# St. Johns River

DATE: June 27, 2018  
TO: Prospective Respondents  
FROM: Amy Lucey, Contracts Administrator  
SUBJECT: Addendum #1 to Invitation for Bids # 33203, 96B Rehabilitation

96B Approach Slab Detail

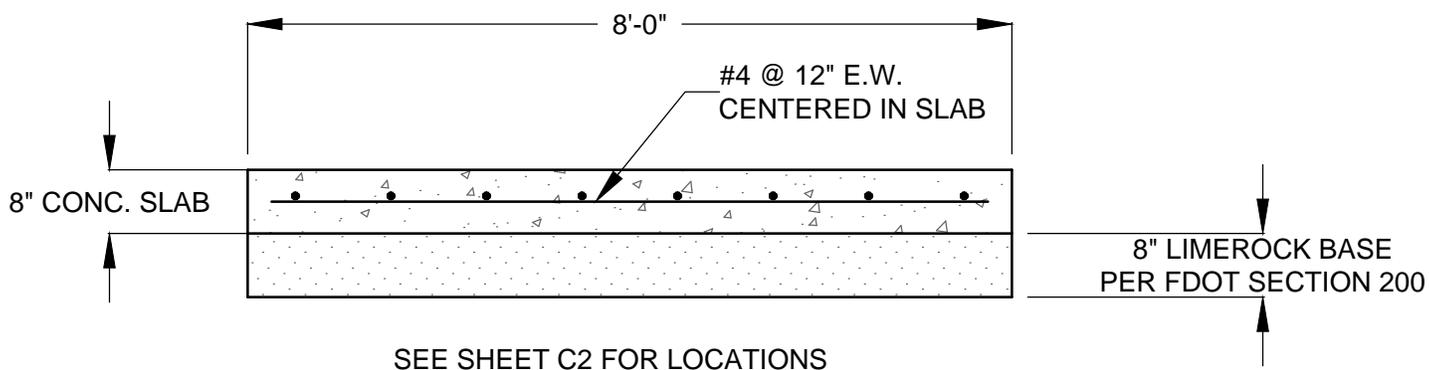
- Page 53, Statement of Work, Task Identification, shall add the following paragraph:  
36. Concrete Bridge Approach Slabs  
Construct cast-in-place reinforced concrete approach slabs as detailed on the drawings.
